THE LOCHS AT ABERDEEN

AN ADDITION TO WICHITA, SEDGWICK COUNTY, KANSAS

RE: SUB 2001-01 -- One- Step Final Plat of THE LOCHS AT ABERDEEN ADDITION

**CASE NUMBER:** SUB 2001-01 -- THE LOCHS AT ABERDEEN

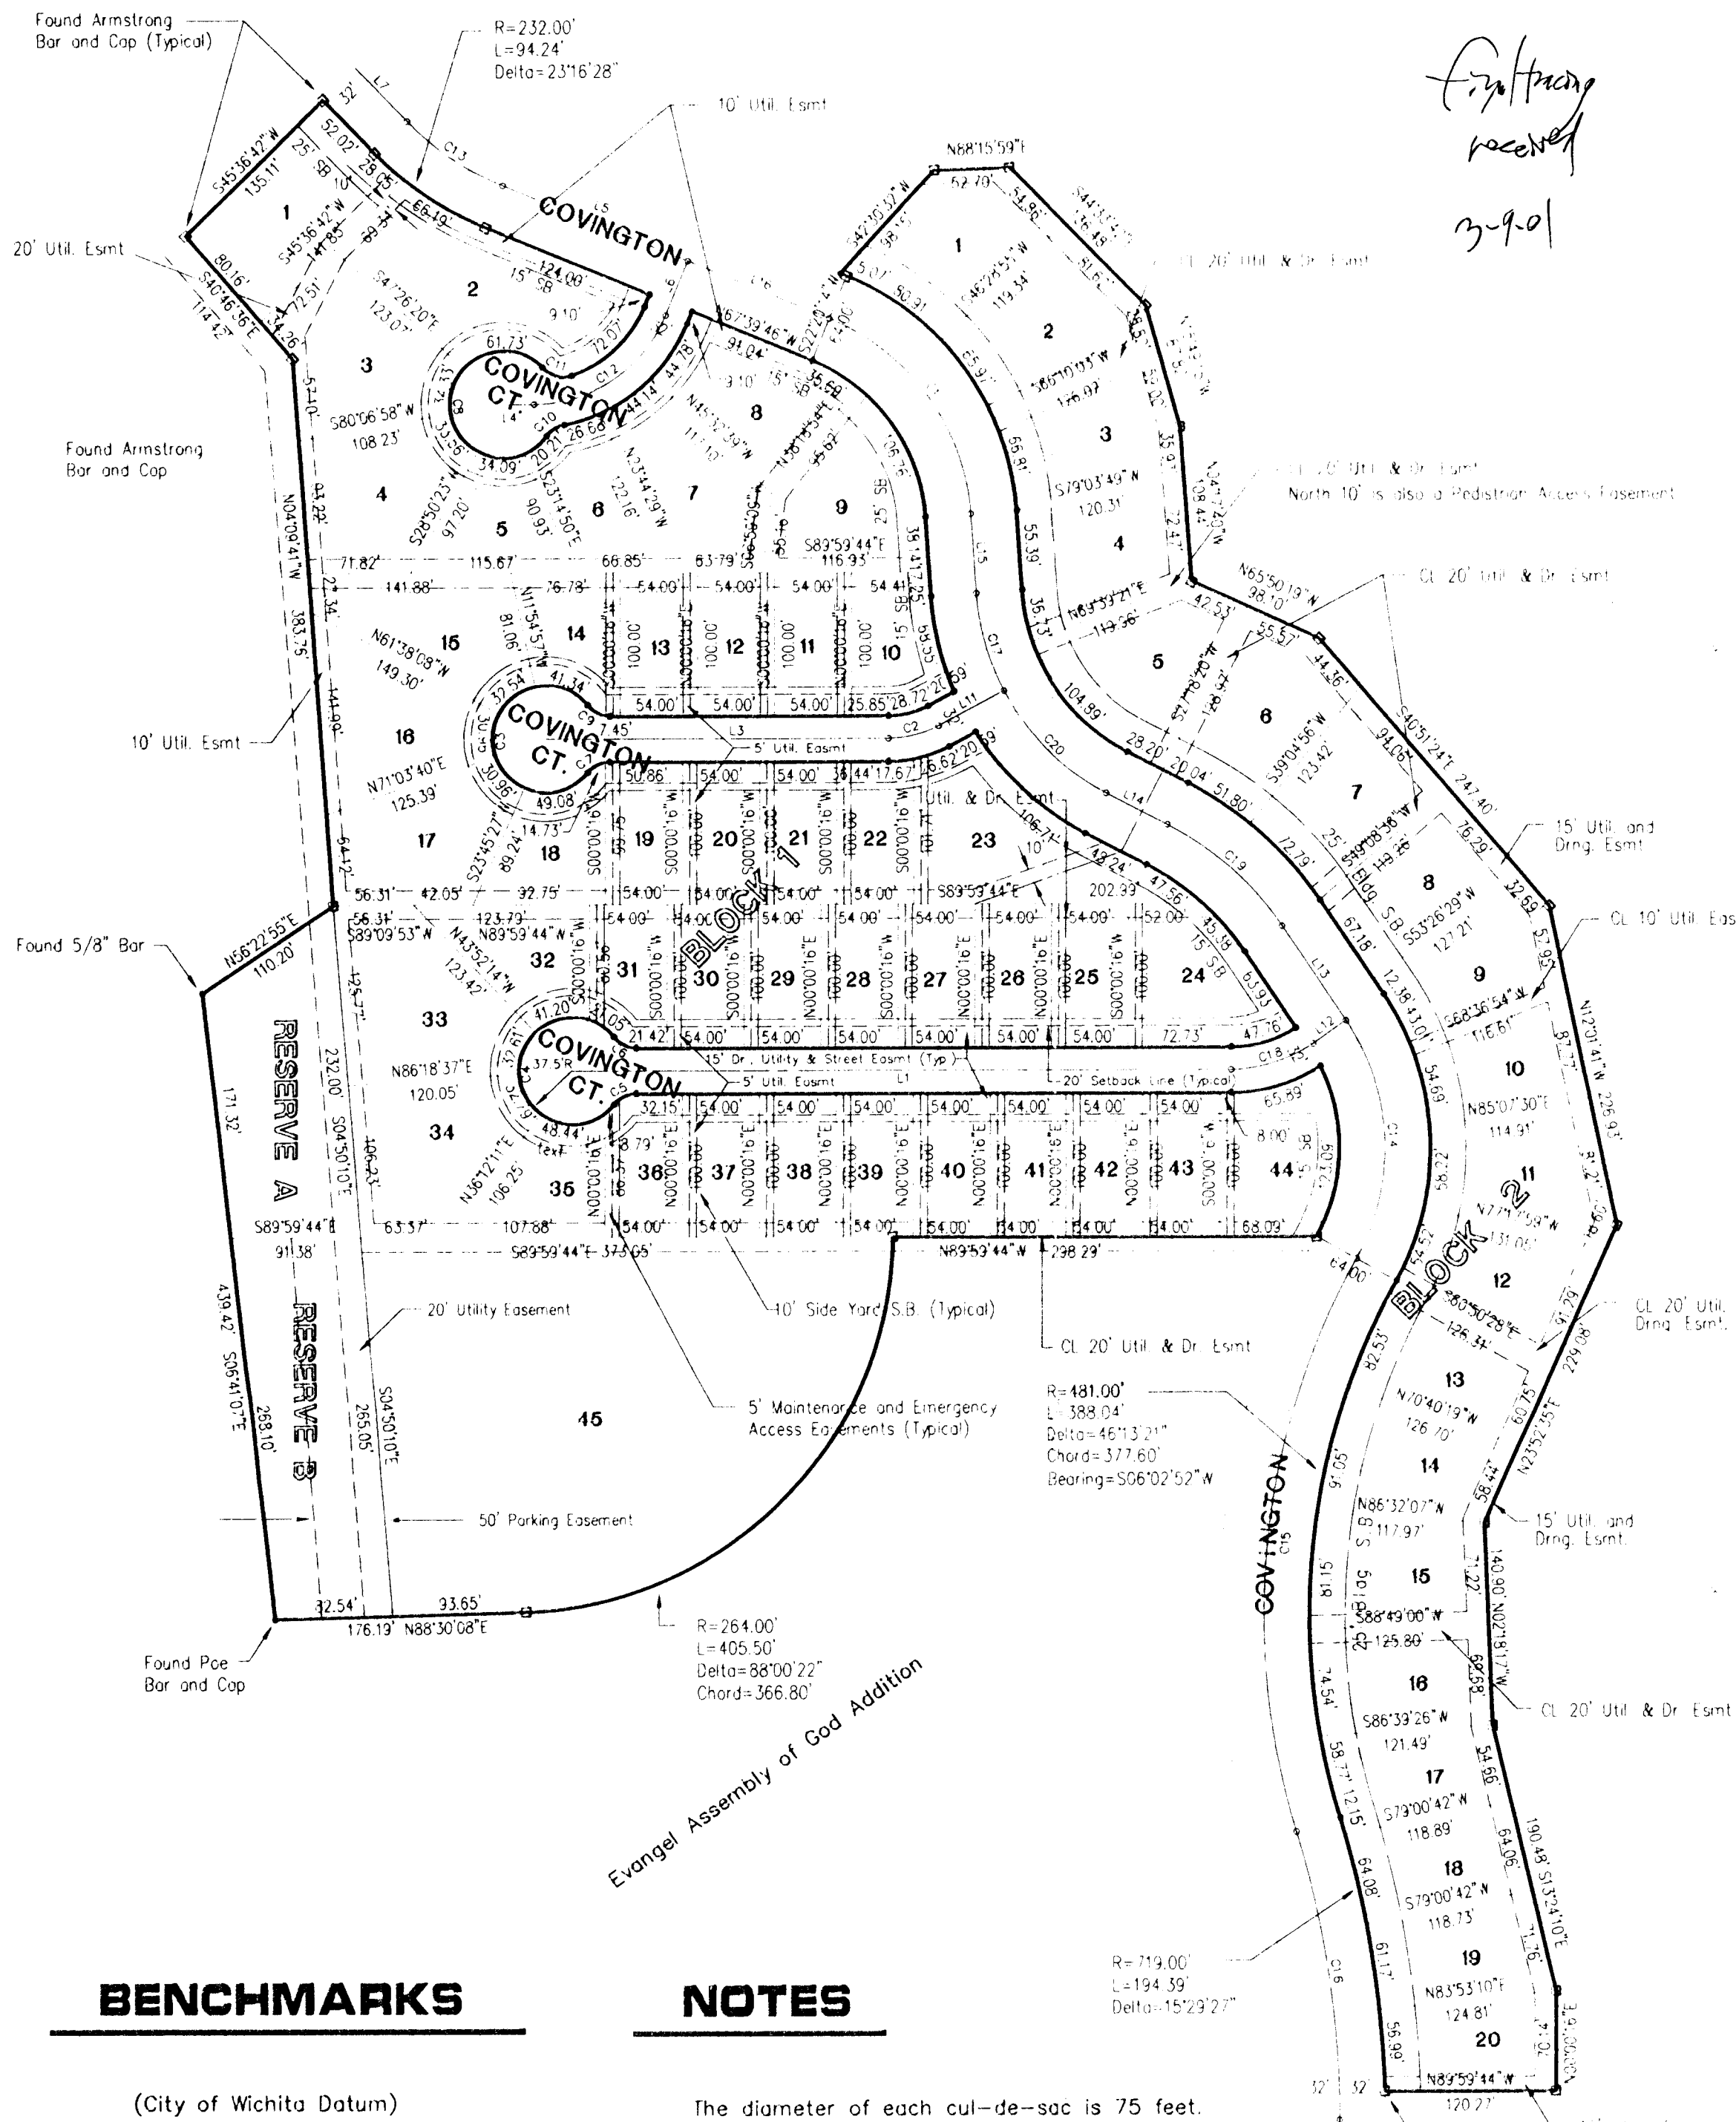
- A. The applicant shall guarantee the extension of sanitary sewer and municipal water to serve the lots being platted. City Engineering needs to comment on the need for additional guarantees or easements for the site. A respread agreement is required.

- C. City Engineering needs to comment on the status of the applicant's drainage plan. The drainage plan is approved. A drainage guarantee is required. Minimum pad elevations need to be platted.

- F. The parking areas intended for Reserves A and B shall be shown on the plat as "parking easements". The easements need to be at least 20-feet deep and no wider than 50 feet. The plat's text shall also reference the platting of these easements.

- G. Because of the landlocked nature of Reserves A and B, a means of access should be provided.
- H. The applicant shall submit a covenant which provides for four (4) off-street parking spaces per dwelling unit on each lot which abuts a 32-foot street. The covenant shall inventory the affected lots by lot and block number and shall state that the covenant runs with the land and is binding on future owners and assigns.

- I. Since this plat proposes the platting of narrow street right-of-way with adjacent 15-foot street, drainage and utility easements, a restrictive covenant shall be submitted which calls out restrictions for lot owner use of these easements. Retaining walls and change of grade shall be prohibited within these easements as well as fences, earth berms and mass plantings.

- L. The MAPC Policy Statement regarding Cluster Development states that each open space area shall be a minimum of 10,000 square feet and that no lot reduced in area shall be more than 500 feet from the nearest open space area. Lots 24, 43 and 44, Block 1 are not located within the required 500 feet from Reserve A. A modification from this design standard has been approved by the Subdivision Committee.

- N. The applicant is advised that the side yard setback may be reduced to 10 feet through cluster development.
- O. In accordance with the Subdivision Regulations, maintenance/emergency access easements shall be platted for development of the zero lot line dwellings. The easements shall be a minimum of five feet in width and referenced in the plat's text with the language as specified in the Subdivision Regulations.

- Q. Lot 7, Block 1, exceeds the maximum lot width to lot depth ratio of 2.5 to 1. *A modification has been approved by the Subdivision Committee.*
- R. The plat does not meet the minimum standards adopted by the Kansas State Board of Technical Professions (Regulation #66-12-1, K.S.A. 74-7037): Plat or Certificate of Survey, item #3, #4, #5, #6, and #10.

- T. The 15-ft drainage and utility easements adjacent to the 32-ft rights-of-way need to also be labeled as street easements.
- U. Lots 19, 24, and 44, Block 1, have missing dimensions.

- V. The easements on Reserves A and B need to be labeled.
- W. The legal description needs to be revised as follows: Line 2, (N89',44"W) needs changed to (S89°59'44"E). Line 10 (N44°23'18" E) needs changed to (N 44°23'18"W). Line 16 (being north of) needs changed to (being west of).

- GG. The representatives from the utility companies should be prepared to comment on the need for any additional utility easements to be platted on this property. KGE has requested additional easements.
